Service Bulletin

Bulletin No.: 21-NA-071

Subject: DTC's P05AE or P059F Set Current or History

Brand:	Model:	Model Year:		VIN:		Engine:	Transmission:
		from	to	from	to		
Chevrolet	Silverado 2500HD/3500HD	2020	2021			All	All
GMC	Sierra 2500HD/3500HD

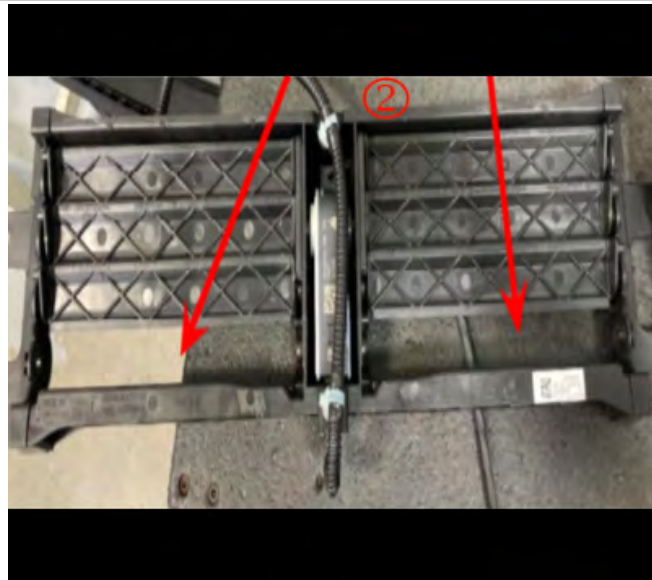
Note: The graphics above show before (1), and after (2), examples of the lower shutter modification.

Remove the front bumper lower shutter and complete the *Lower Shutter Louver Modification Procedure* below, to remove the lowest row of louvers from the shutter.

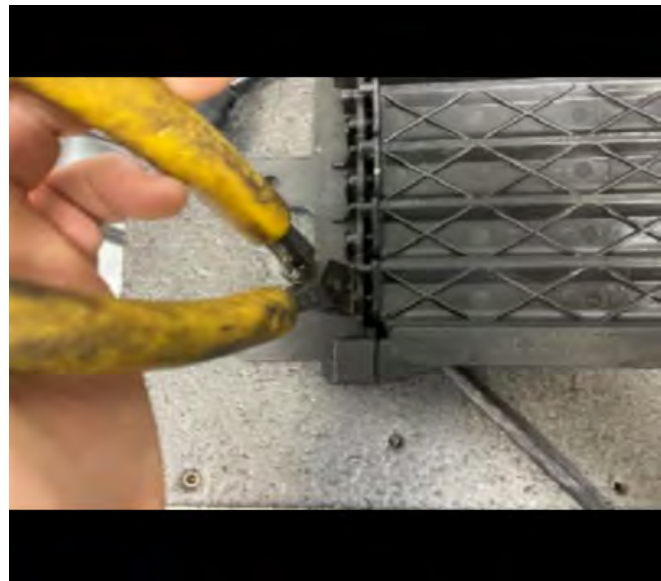
2. Using side cutters, snip the outer pivot pins of the 2 lower louvers.

Tip: Pushing the lower louver outboard will allow you to cut more of the pin, which will aid in the louver removal later in the procedure.

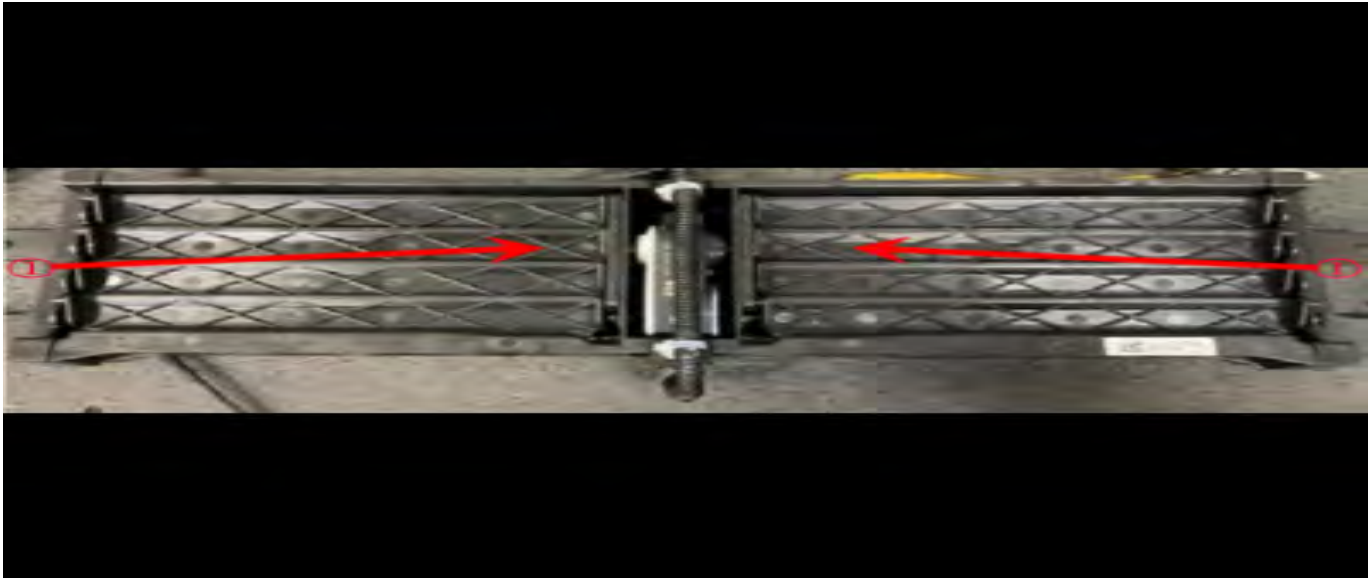
Note: The preferred way to open the louvers is to apply pressure on the drive louvers (1).

3. If not already open, rotate all louvers to the open position.

Note: This step is done to prevent damage to the frame or actuator when completing step # 5.

4. As shown in the graphic above, insert the putty knife between the link bar and the center of the shutter frame. This is the area closest to the actuator motor.

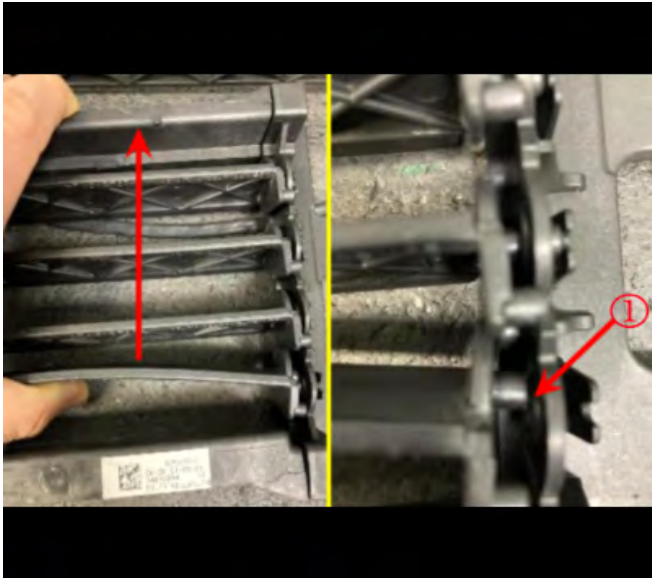
Tip: This cut is easier to accomplish with the shutter standing on end.

5. Using the rotary tool, cut the link bar (2) of the lowest louver (3), just below the louver link pin (1) above the lowest row.
6. Remove the lower louver following the steps below.

- 6.1. Bend the louver upwards until the previously cut outboard pivot pin (1) ejects out of the hole.
- 6.2. Then remove the louver and the cut link section.
